Re: Request to Designate the Vivian Sand Extraction Project Based on Missing and Misleading Information in the Vivian Sand Extraction EAP and the Hydrogeology and Geochemistry Assessment Report prepared by AECOM Canada Ltd.

The EAP and HGR have been completed for the Vivian Sand Extraction Project now undergoing licensing review. The reports can be found in the Manitoba Public Registry 6119.00 - Silica Sand Extraction Project - CanWhite Sands Corp.

Figure 2. Slumping of sand pillars leading to subsidence between well clusters. Figure 2-3 from the CWS EAP was modified for this figure.

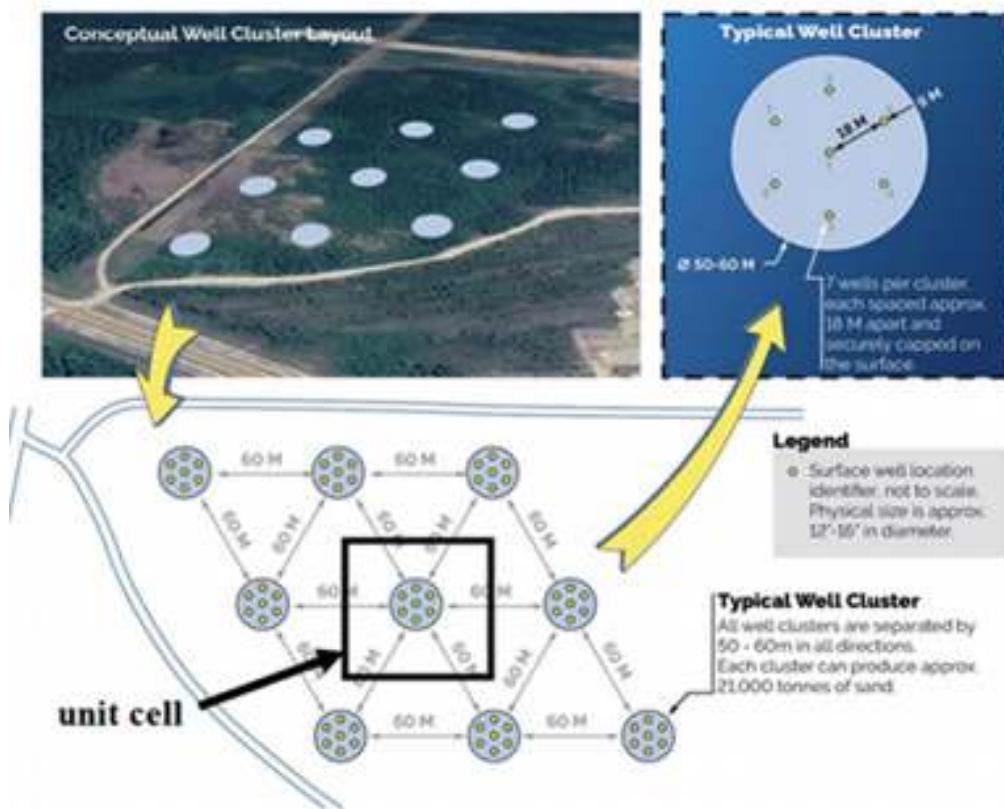
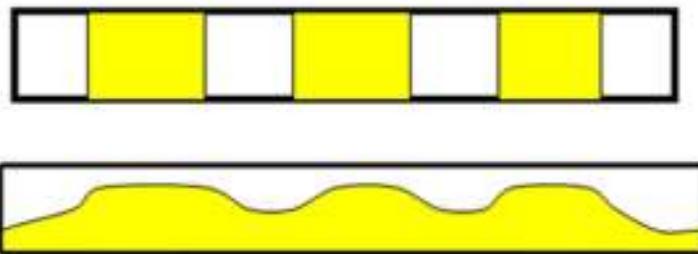
Sand slumping will enlarge the cavities under the well clusters creating an ever more unstable situation. Figure 2 illustrates the geometry of the well clusters and a unit cell within the clusters. The unit cell in figure 2 is 114 meters wide by 98.7 meters high with a central cavity of 54 meters in diameter. The extraction ratio in the sand layer for the unit cell shown is 0.203 (~20%). The unit cell and the 20% extraction ratio in the sand layer repeats as the clusters expand. The extraction ratio quoted in the EAP for the processing plant of 5% would include the layers of limestone and glacial till above the sand layer thus giving a much smaller extraction ratio.

As the sand slumps into the cavities the unsupported cavity area will increase as the extraction proceeds. Eventual collapse of the limestone and till and subsequent subsidence is inevitable over the entire area of the well clusters.

The sand layer from the well log for Bru 95-7 documented in the HGR to be 20 meters is representative of the initial area where extraction is planned. The maximum sand extraction depth according to the HGR is 25 meters. Thus the average depth of the general subsidence would be 4 to 5 meters based on an extraction ratio of 0.2 (20%) in the sand layer. A huge ever growing depression from subsidence would result that would fill with surface water. The depth of the depression is likely to vary from a few meters to up to 20 meters depending on the degree of slumping and sinkhole formation. Individual sinkholes could form for a well cluster to a depth of 20 meters (the total depth of the sand layer). The general subsidence area covered by all well clusters could be punctuated with these deeper sinkholes.
